ADDENDUM

PROJECT: Jefferson Community Health Center
Patient Wing and Administration Renovation
Fairbury, Nebraska

AD-2

DATE ISSUED: Friday, January 25, 2013

8
Skylight Detail
 Scale: 1 1/2" = 1'-0"

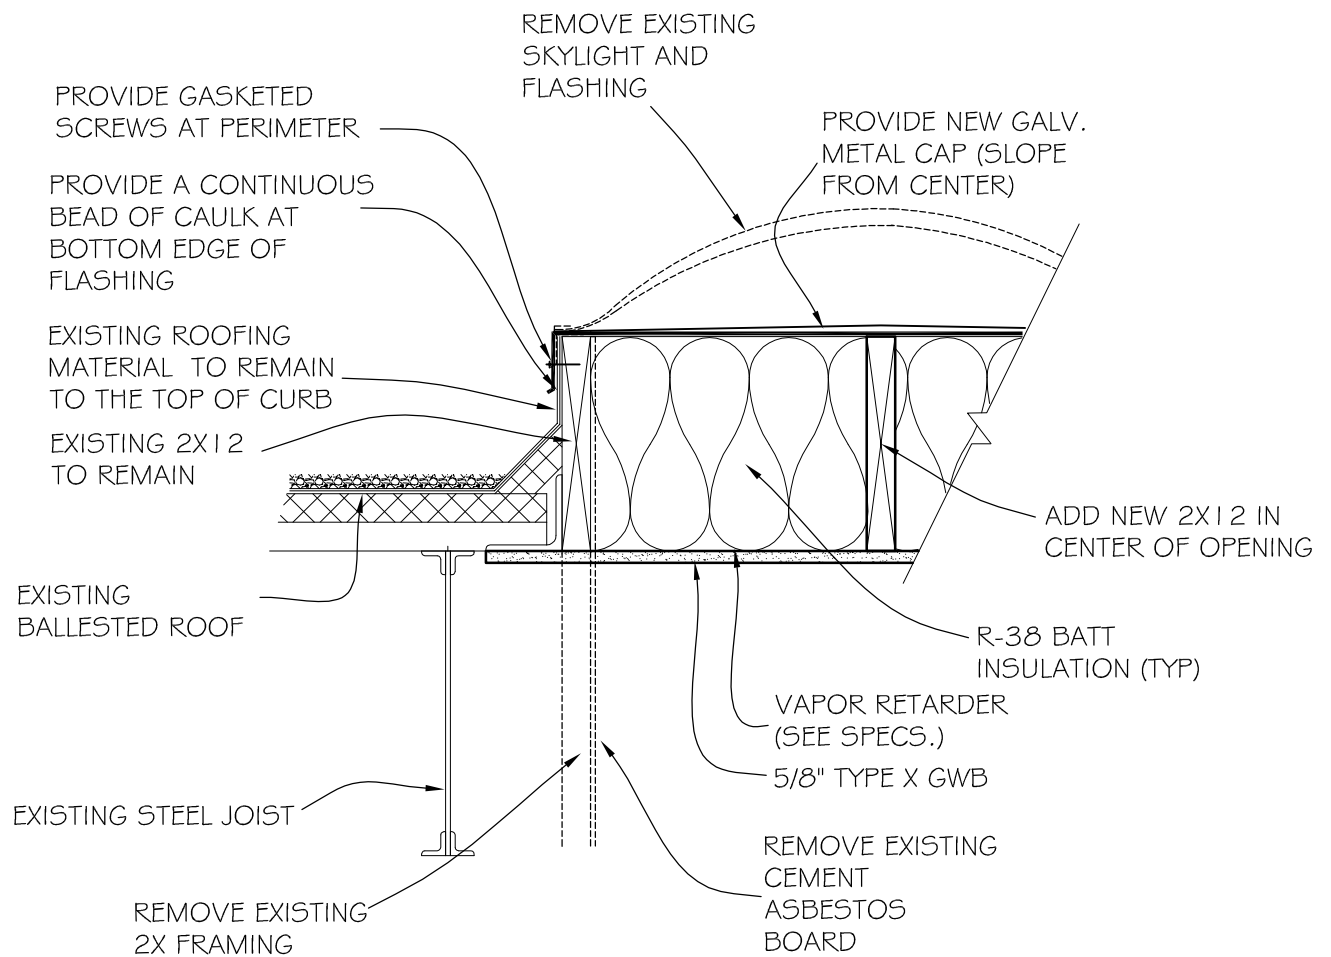
In reference to **Sheet A-104**, see attached Sheet A-104.1 for sky light infill detail.

1 Patient Room Elevation
Scale: 1/4" = 1'-0"

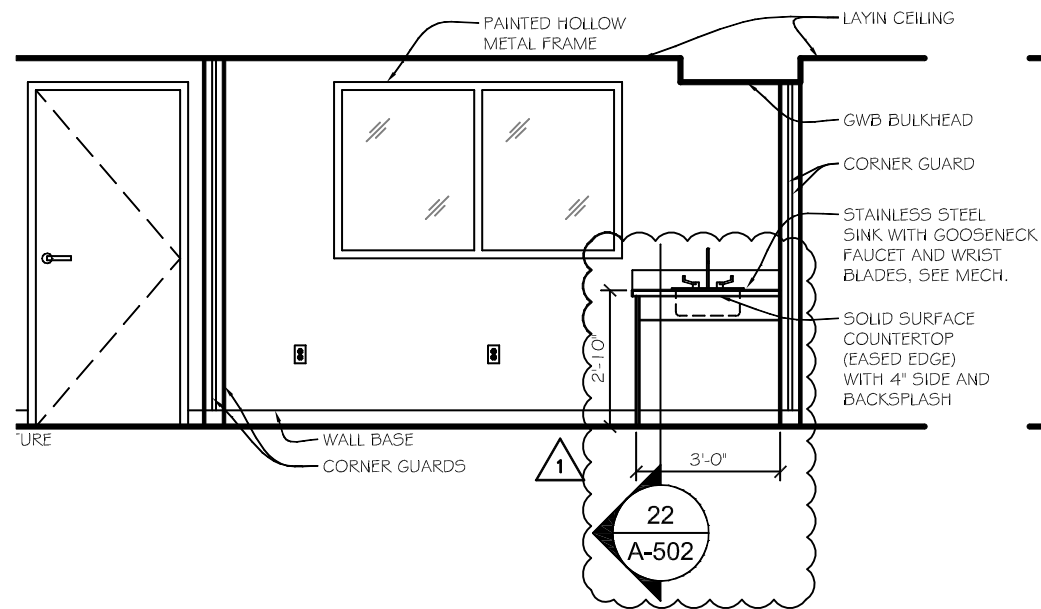
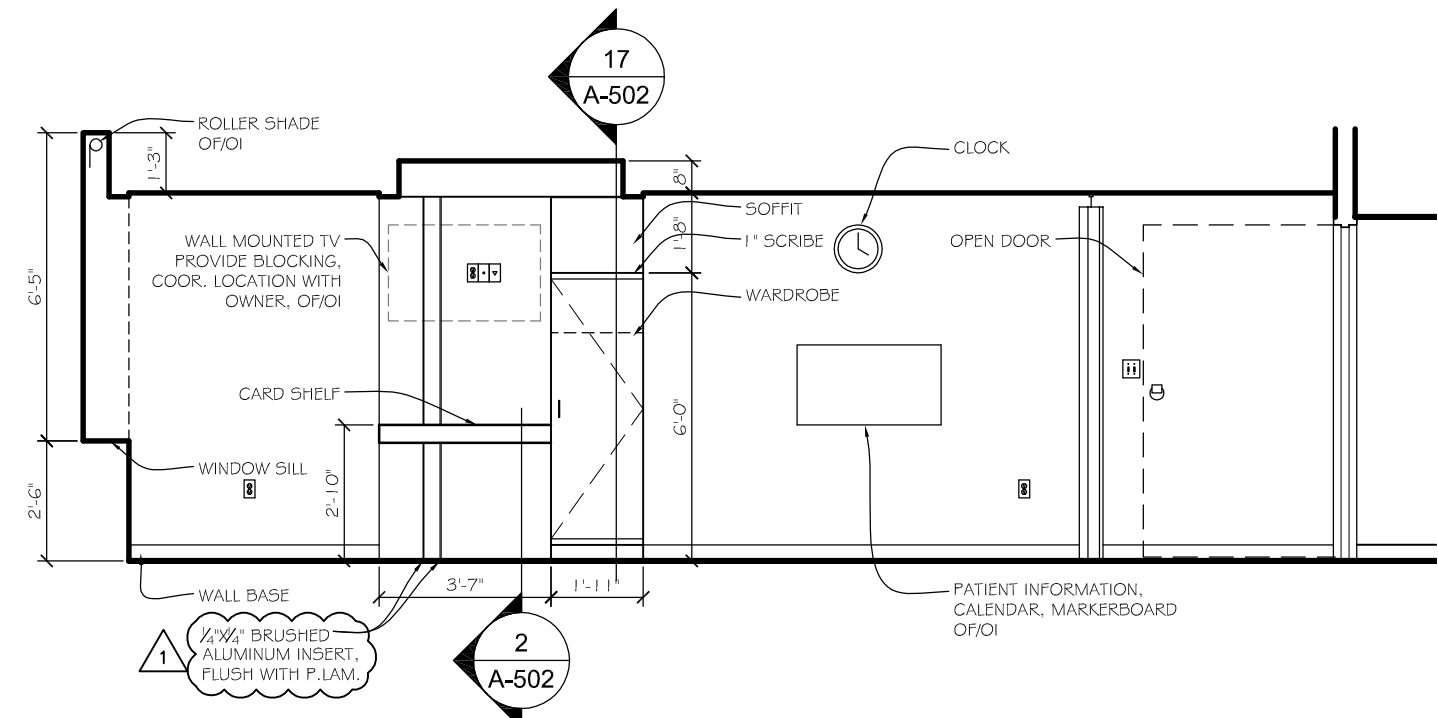
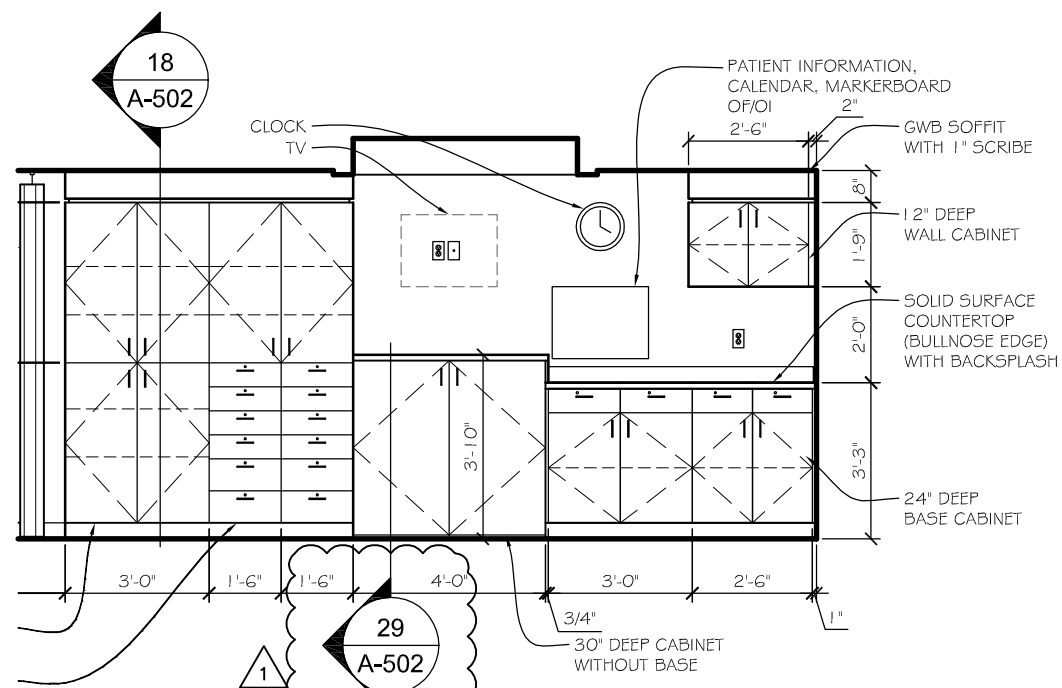
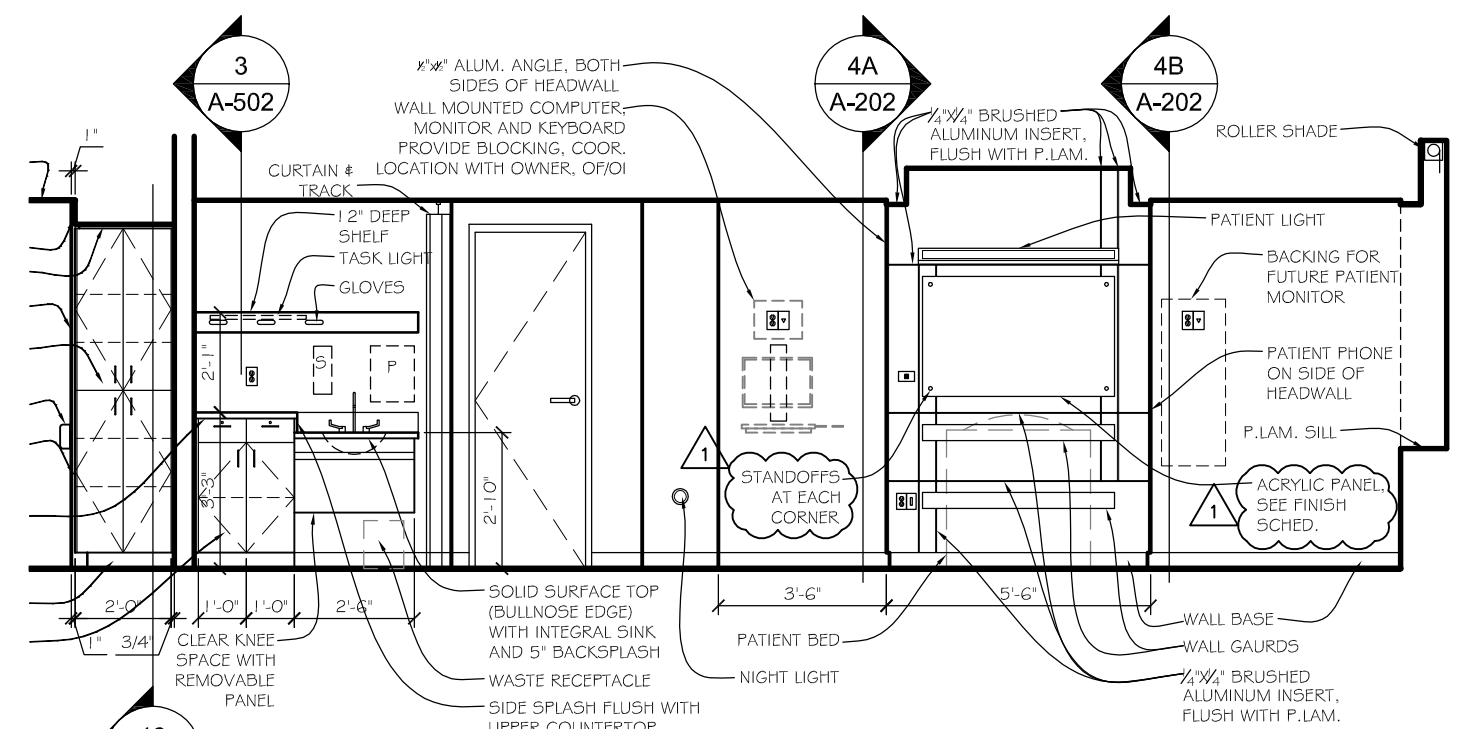
In reference to **Sheet A-202**, see attached Sheet A-202.1 for revised interior elevations

Toilet 153 B Elev.

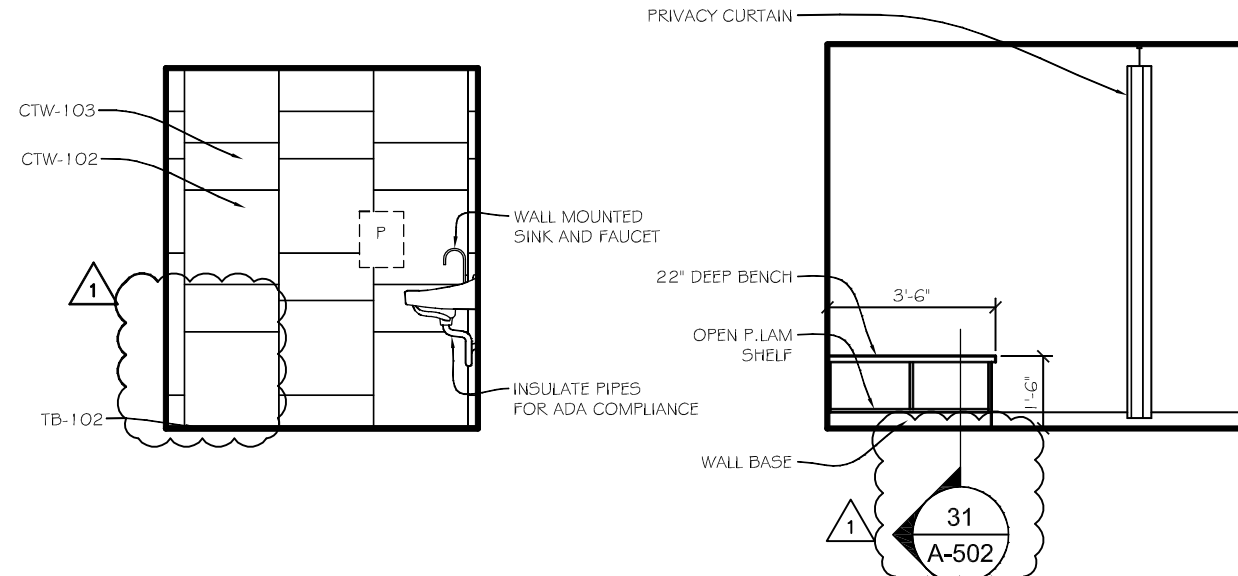
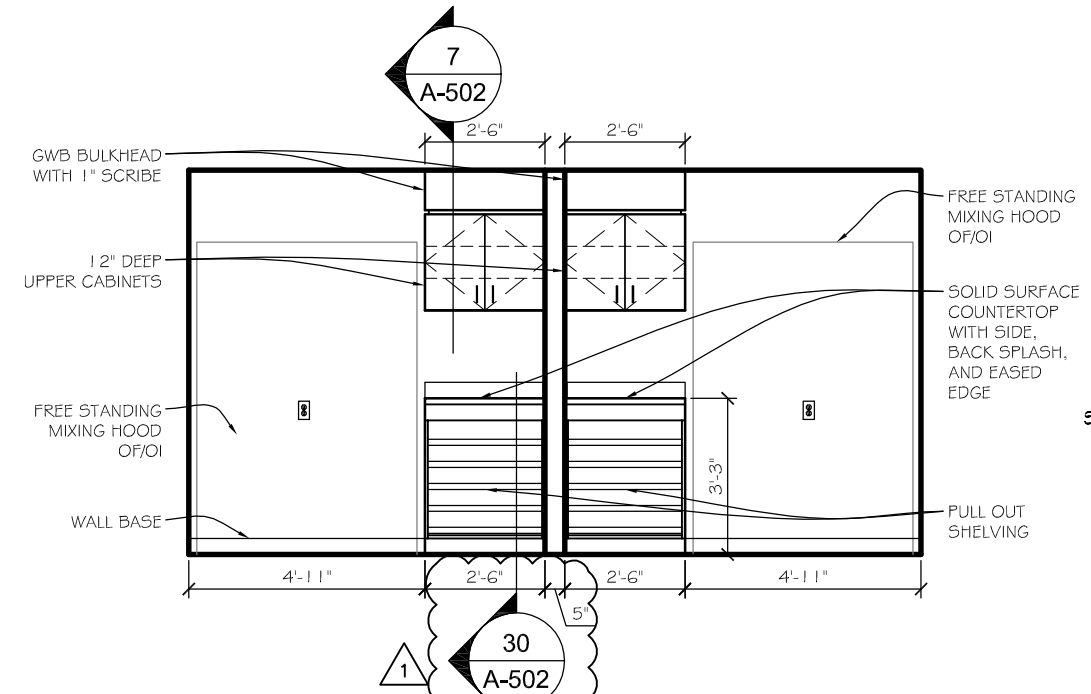
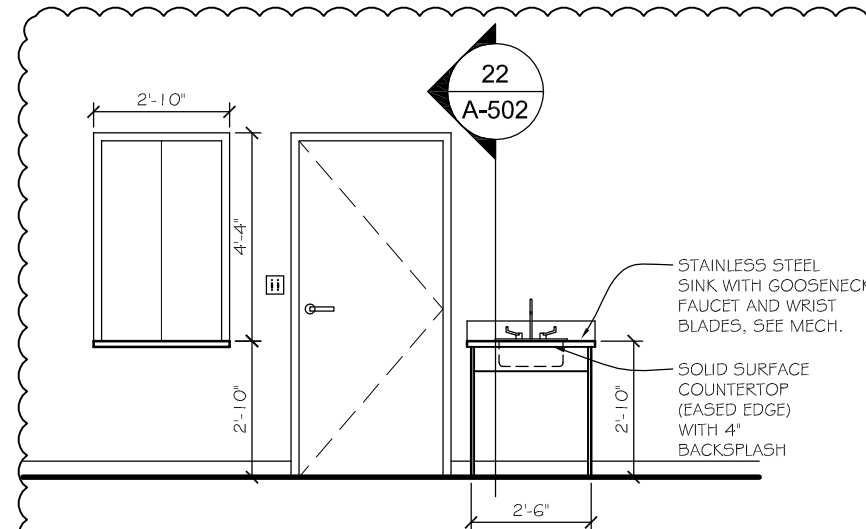
In reference to **Sheet A-203**, see attached Sheet A-203.1 for revised interior elevations
